Building Permit Application

Permit No.: B14003663

Building Address: 15229 Sweetbay St.
 City: WOODBINE State: MD Zip Code: 21797
 Suite/Apt. # _____ SDP/WP/BA #: F-07-38
 Census Tract: _____ Subdivision: BELLE HAVEN
 Section: _____ Area: _____ Lot: 41
 Tax Map: _____ Parcel: _____ Grid: _____
 Zoning: _____ Map Coordinates: _____ Lot Size: _____

RE: Belle Haven Estates
lot 41 B14003663
5229 ~~1827~~ SWEETBAY STREET
WOODBINE MD. 21797

SHEET NUMBER
5A

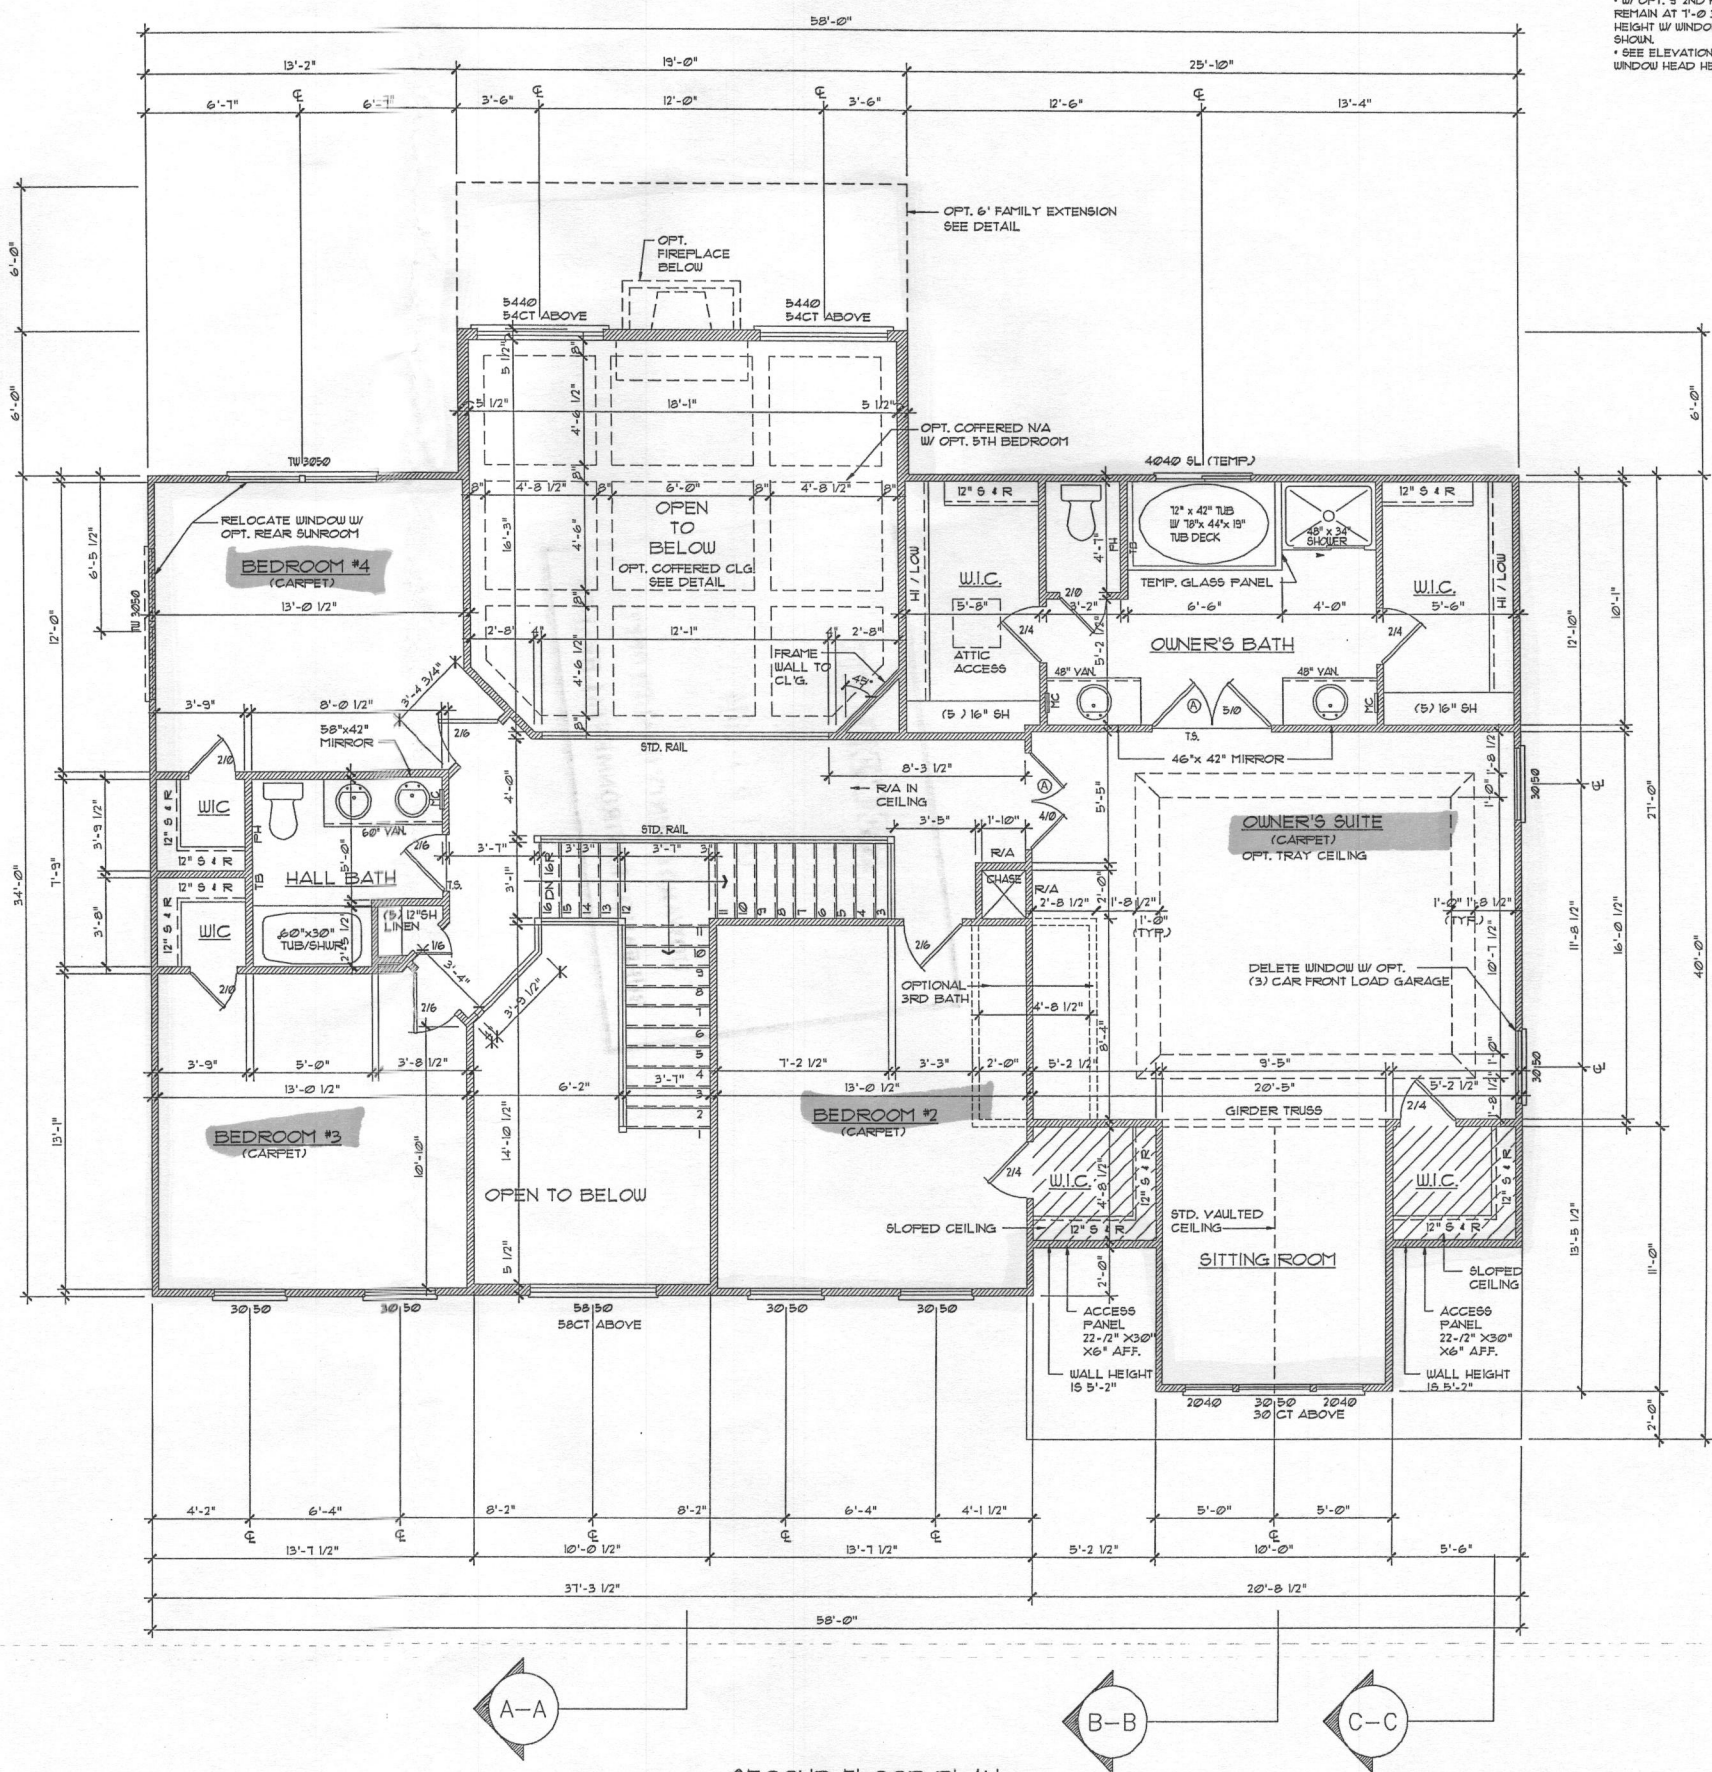
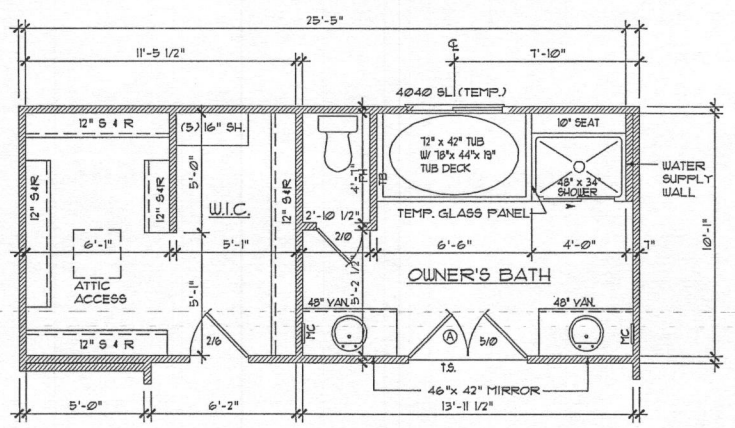
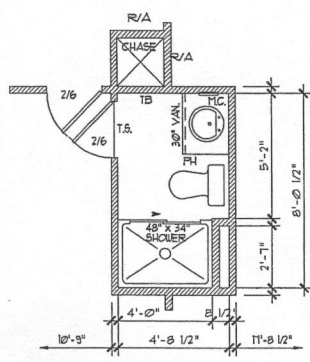
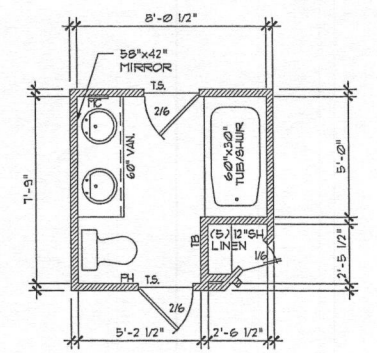
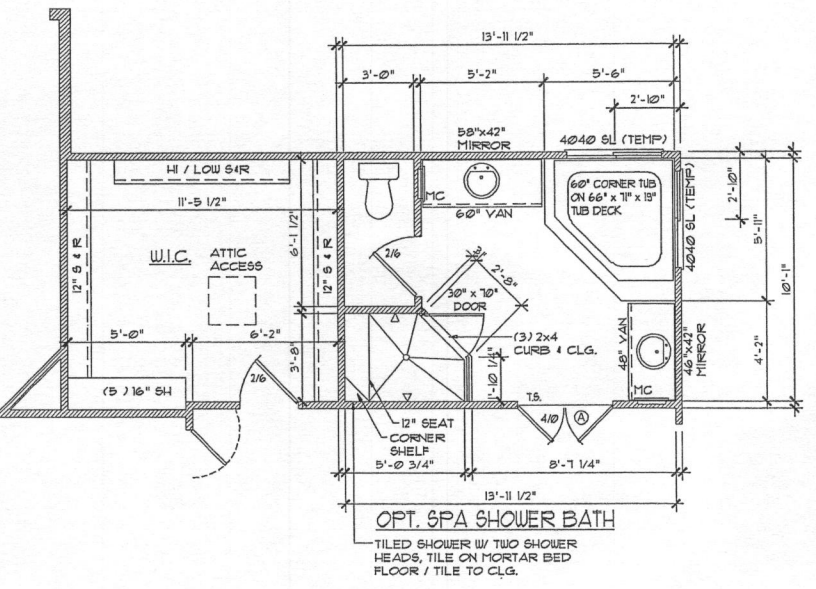
Building permit B14003663 cannot be approved at this time because you still have 5 bedrooms. Even though your basement is not finished you will still have the ability to create five bedrooms because the full bathroom is attached to the den/bedroom. The den/bedroom can be transformed into a bedroom with drywall. Please make adjustments and resubmit. If you would like to have the permit approved as is. We must submit a revised building plan to the department of planning and zoning and to the Howard County health department stating the septic system is designed for a 4 bedroom house and if the homeowner decides to upgrade the unfinished den/bedroom in the basement the septic system must be upgraded. If you have any questions don't hesitate to give me a call.

NOTE ADDED 12/2: AT ANY TIME IN THE FUTURE THAT A BUILDING PERMIT IS SUBMITTED TO FINISH THE AREA CURRENTLY IDENTIFIED AS OPTIONAL DEN, THE SEPTIC SYSTEM UPGRADE WILL BE REQUIRED AS FINISHING THE OPTIONAL DEN CREATES A FIFTH BEDROOM PER HOWARD COUNTY CODE 3-801(B)

REVISED
Date: 12/2/14
Comments: B14003663
PER HEALTH
KV_003_3258_COLORADO

LOT 41
15229 SWEETBAY STREET
WOODBINE, MD 21797
PLOT PLAN
KHOV ELEVATION

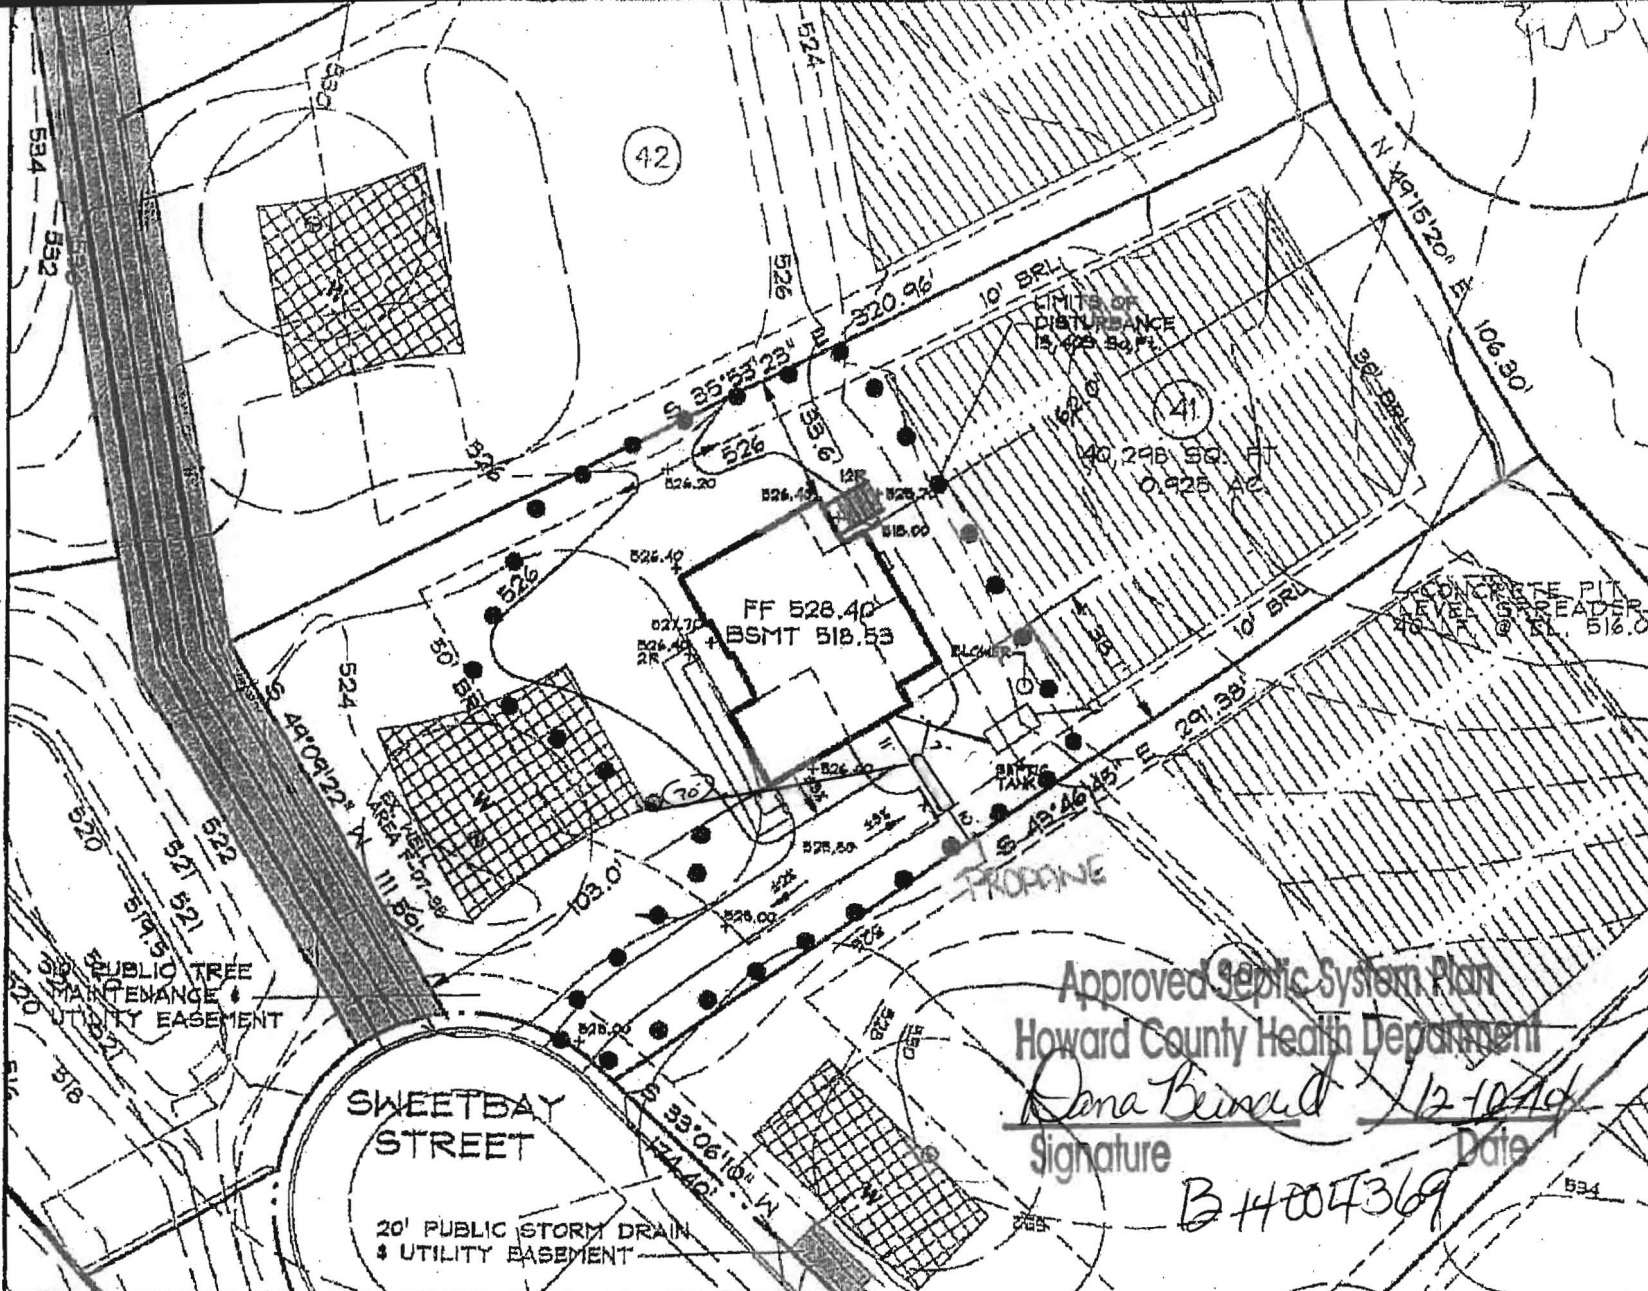
There are ^{no} changes to the structural plans. A revised site plan is attached, changing General Note # 2 to reflect 4 bedrooms.

1. THE EXISTING WELL SHOWN ON THIS PLAN (HO-95-0649) HAS BEEN LOCATED BY DDC, PROFESSIONAL LAND SURVEYOR, AND IS ACCURATELY SHOWN.
2. BASE SQUARE FOOTAGE OF HOUSE: 3,562 sq.ft.
NUMBER OF BEDROOMS: 4
3. INFORMATION SHOWN ON THIS PLAN BASED ON PLANS PREPARED BY DMW DATED 6/25/07, EXISTING TOPOGRAPHY BASED ON GRADING PLAN PREPARED BY DEMARIO DESIGN CONSULTANTS DATED 7/9/07 AND FIELD RUN TOPOGRAPHY PREPARED BY DDC INC IN JAN. 2012
4. A DRIVEWAY CULVERT IS NOT REQUIRED PER THE APPROVED ROAD DRAWINGS F-07-98.
5. EJECTOR PUMP REQUIRED TO SEWER BASEMENT.

REVISED

Comments: B14003663

LOT 41
15229 SWEETBAY STREET
WOODBINE, MD 21797
PLOT PLAN
KHOV ELEVATION

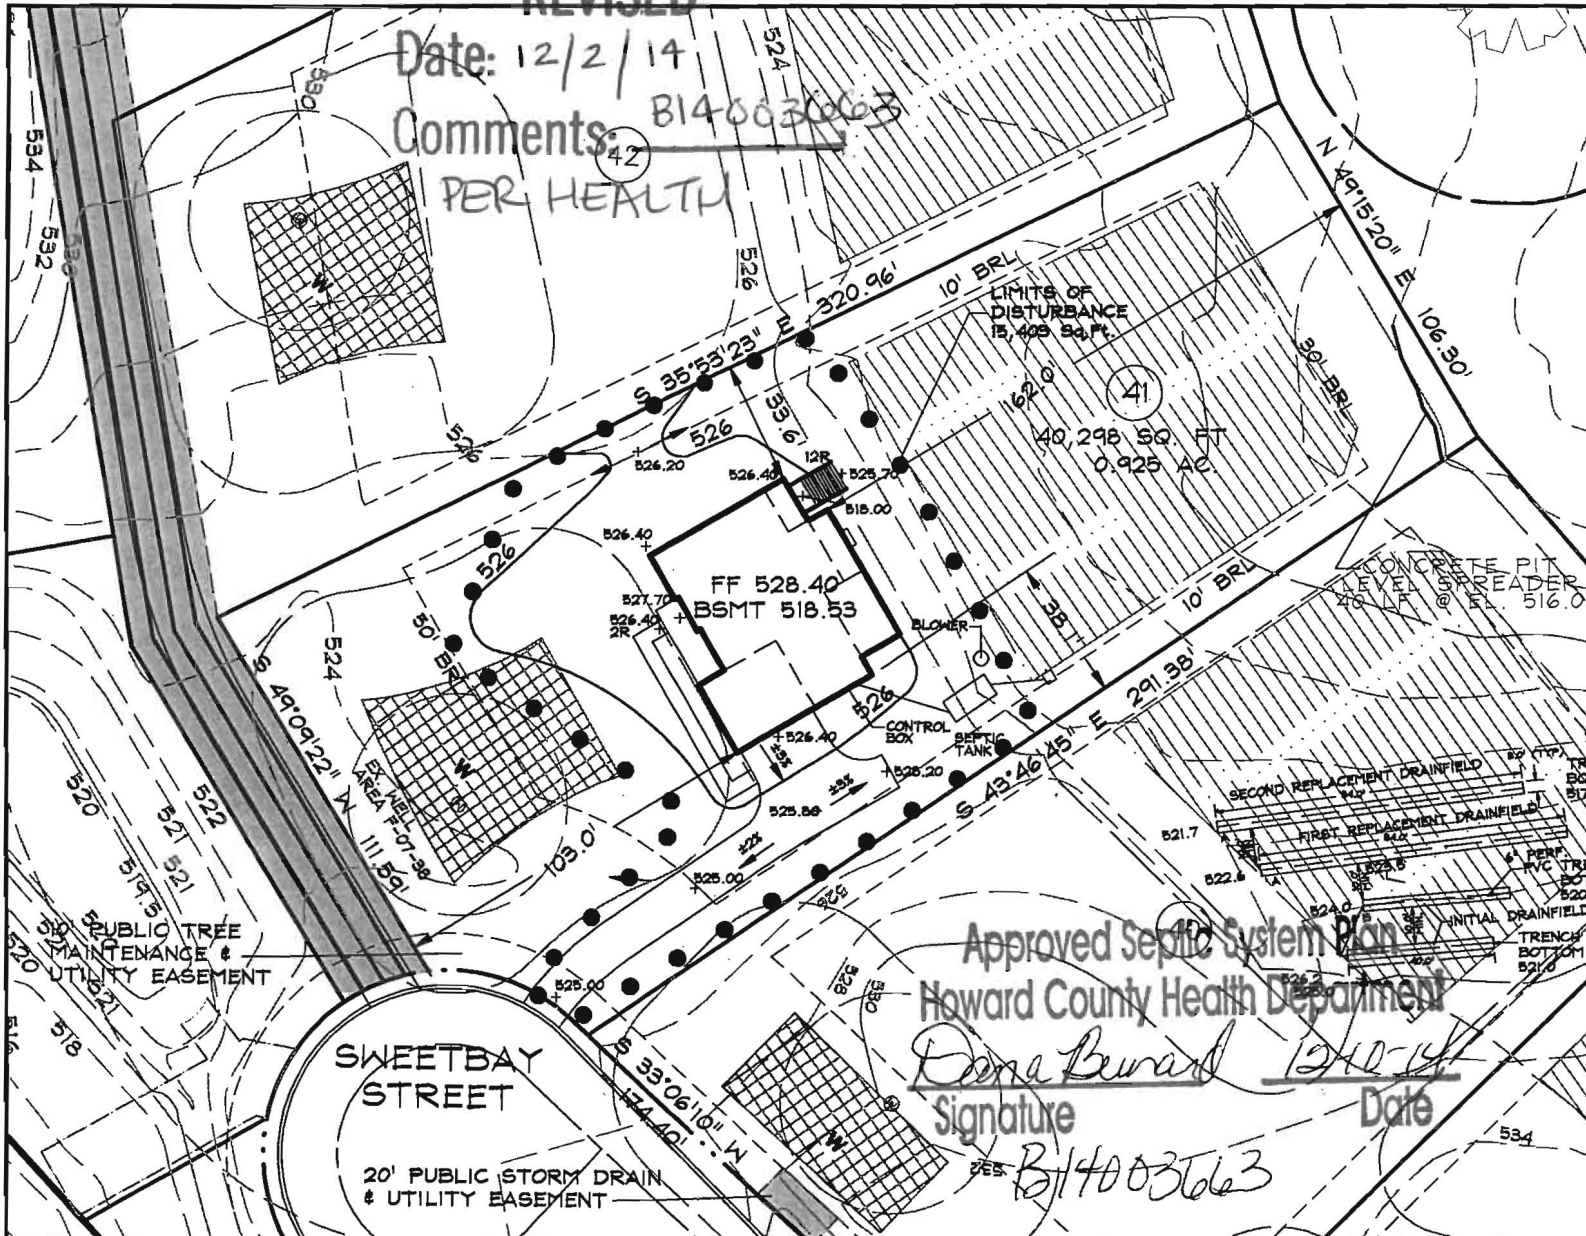
- (2) Amend the number of bedrooms from 5 to 4. As the finished rec room is not considered a bedroom there are only 4 total.

1. THE EXISTING WELL SHOWN ON THIS PLAN (HO-95-0649) HAS BEEN LOCATED BY DDC, PROFESSIONAL LAND SURVEYOR, AND IS ACCURATELY SHOWN.
2. BASE SQUARE FOOTAGE OF HOUSE: 3,562 sq. ft. NUMBER OF BEDROOMS: 4
3. INFORMATION SHOWN ON THIS PLAN BASED ON PLANS PREPARED BY DMW DATED 6/25/07. EXISTING TOPOGRAPHY BASED ON GRADING PLAN PREPARED BY DEMARIO DESIGN CONSULTANTS DATED 7/9/07 AND FIELD RUN TOPOGRAPHY PREPARED BY DDC INC IN JAN. 2012
4. A DRIVEWAY CULVERT IS NOT REQUIRED PER THE APPROVED ROAD DRAWINGS F-07-38.
5. EJECTOR PUMP REQUIRED TO SEWER BASEMENT.
6. AT ANY TIME IN THE FUTURE THAT A BUILDING PERMIT IS SUBMITTED TO FINISH THE AREA CURRENTLY IDENTIFIED AS OPTIONAL DEN, THEN A SEPTIC SYSTEM UPGRADE WILL BE REQUIRED AS FINISHING THE OPTIONAL DEN CREATES A FIFTH BEDROOM PER HOWARD COUNTY CODE 3.801(B).
